SUBJECT: AMENDMENT NO. 19 TO FACILITY OPERATING LICENSE NPF-86: REACTOR
COOLANT SYSTEM PRESSURE/TEMPERATURE LIMITS - LICENSE AMENDMENT
REQUEST 92-06 (TAC M84344)

SEABROOK STATION, UNIT NO. 1

Amendment No.19
License No. NPF-86

SAFETY EVALUATION BY THE OFFICE OF NUCLEAR REACTOR REGULATION
RELATED TO AMENDMENT NO. 19 TO FACILITY OPERATING LICENSE NO. NPF-86
NORTH ATLANTIC ENERGY SERVICE CORPORATION
SEABROOK STATION, UNIT NO. 1
DOCKET NO. 50-443

FIGURE 3.4-2

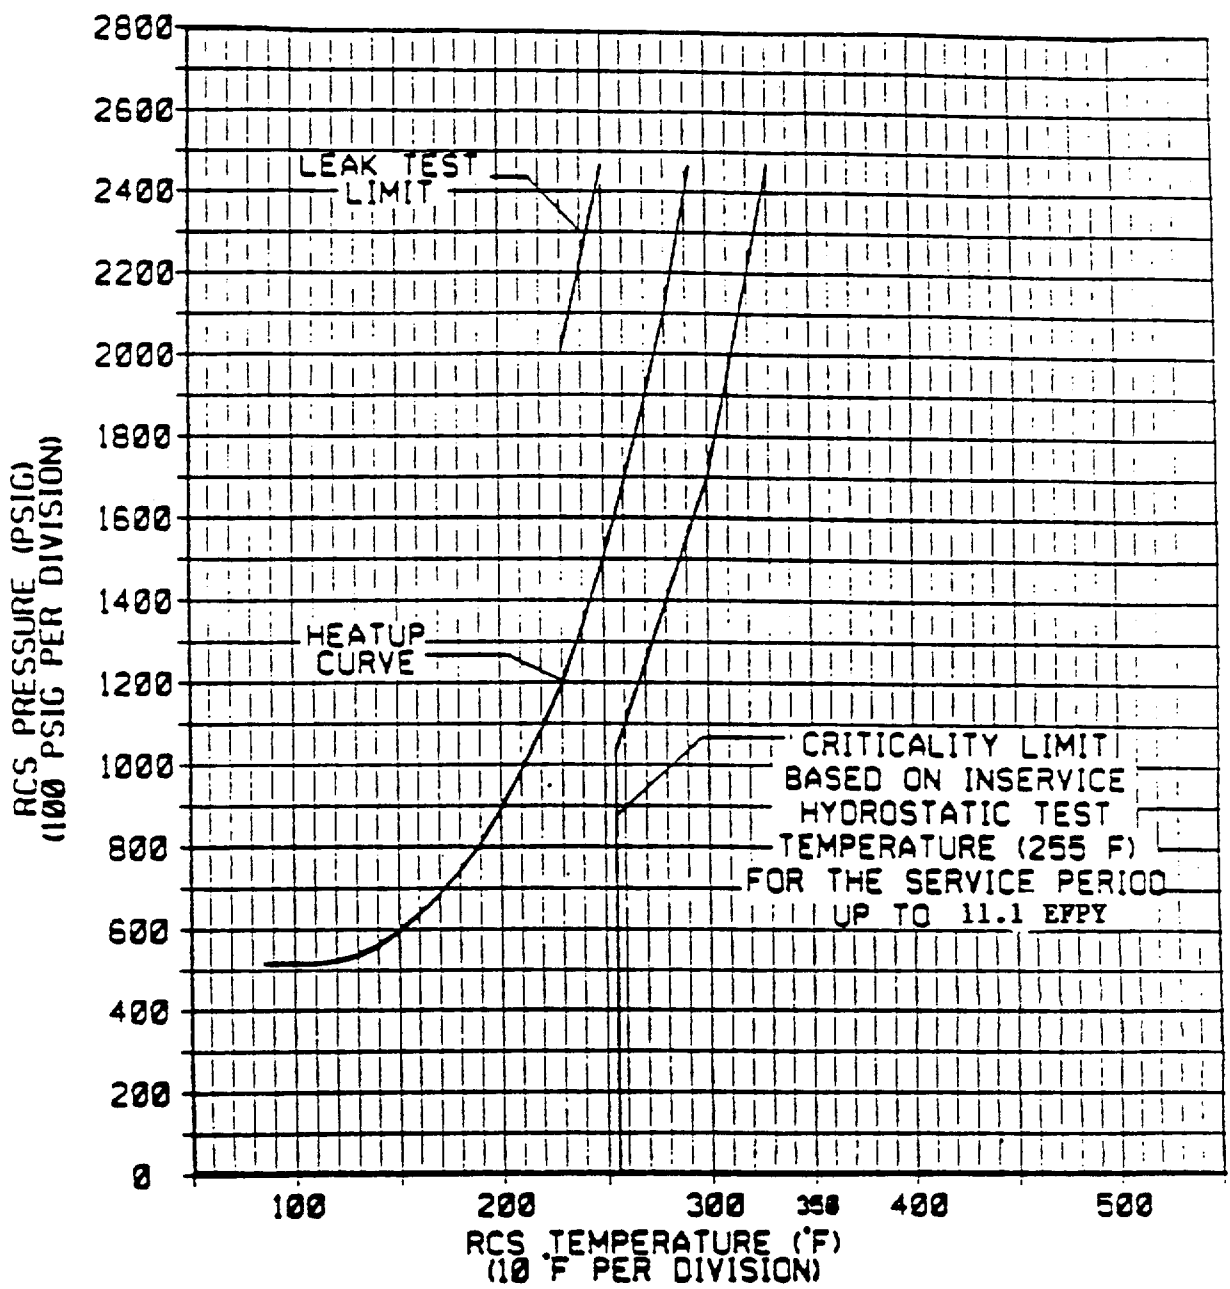
The amendment revises the Appendix A Technical Specifications (TSs) relating
to Reactor Coolant System heatup and cooldown limitations. Specifically,
Figures 3.4-2 and 3.4-3 are modified to show applicability of the curves up to
11.1 equivalent full-power years (EFPY), to provide revised RT_{NDT} values at
11.1 EFPY at 1/4 and 3/4 thickness, and to indicate the copper content of the
controlling material. These changes implement commitments made by North
Atlantic Energy Corporation (letter G. Thomas to USNRC dated November 30,
1988) in response to Generic Letter 88-11.

Curve applicable for heatup rates up to 60°F/hr for the service period up to 11.1 EFPY and contains margins of 10°F and 60 psig for possible instrument errors

Controlling material:	base metal
Copper content:	0.06 WT%
RT _{NDT} initial:	40°F
RT _{NDT} after 11.1 EFPY:	1/4T, 108°F
	3/4T, 86°F

The staff has evaluated the effect of neutron irradiation embrittlement on each beltline material in the Seabrook reactor vessel under RG 1.99 (Rev. 2). The staff determined that the limiting material with the highest ART at 11.1 EFPY is the lower shell plate, R1808-3, with 0.06% Cu, 0.57% Ni, and initial RTndt of 40°F. At the 1/4T and 3/4T locations the staff calculated ART values of 107°F and 85°F, respectively, for 11.1 EFPY.

NAESCO used the method in RG 1.99 (Rev. 2), to calculate an ART of 108°F at 1/4T and 86°F at 3/4T for 11.1 EFPY. The difference between licensee's ART and the staff's ART is due to round off error in the staff's calculation of ART values.

Substituting the staff's ARTs into equations in SRP 5.3.2, the staff verified that the proposed P/T limits meet the beltline material requirements in Appendix G.

FIGURE 3.4-3

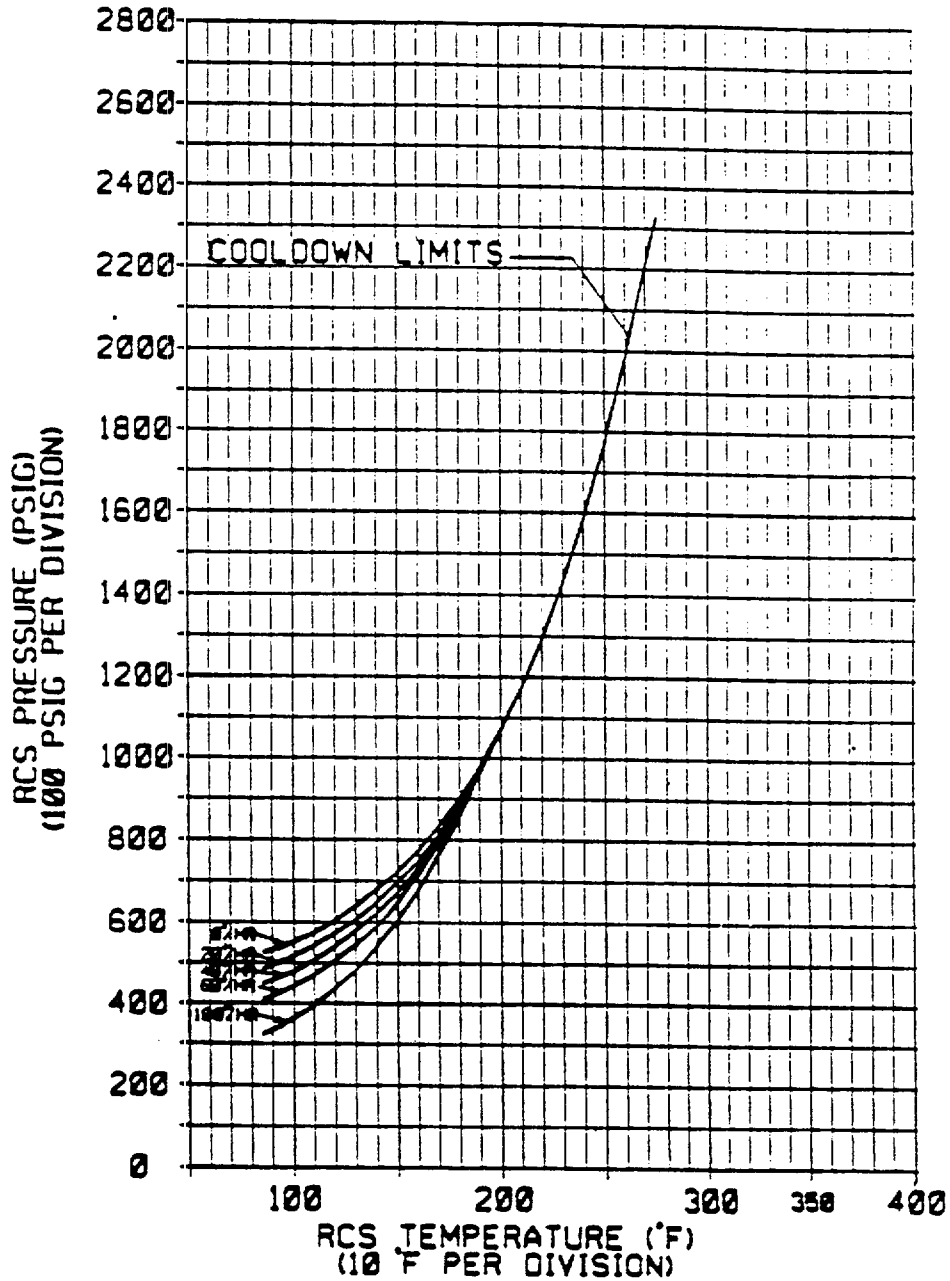
Curve applicable for cooldown rates up to 100°F/hr for the service period up to 11.1 EFPY and contains margins of 10°F and 60 psig for possible instrument errors

RT_{NDT} initial: 40°F
 RT_{NDT} after 11.1 EFPY: 1/4T, 108°F
 RT_{NDT} 3/4T, 86°F
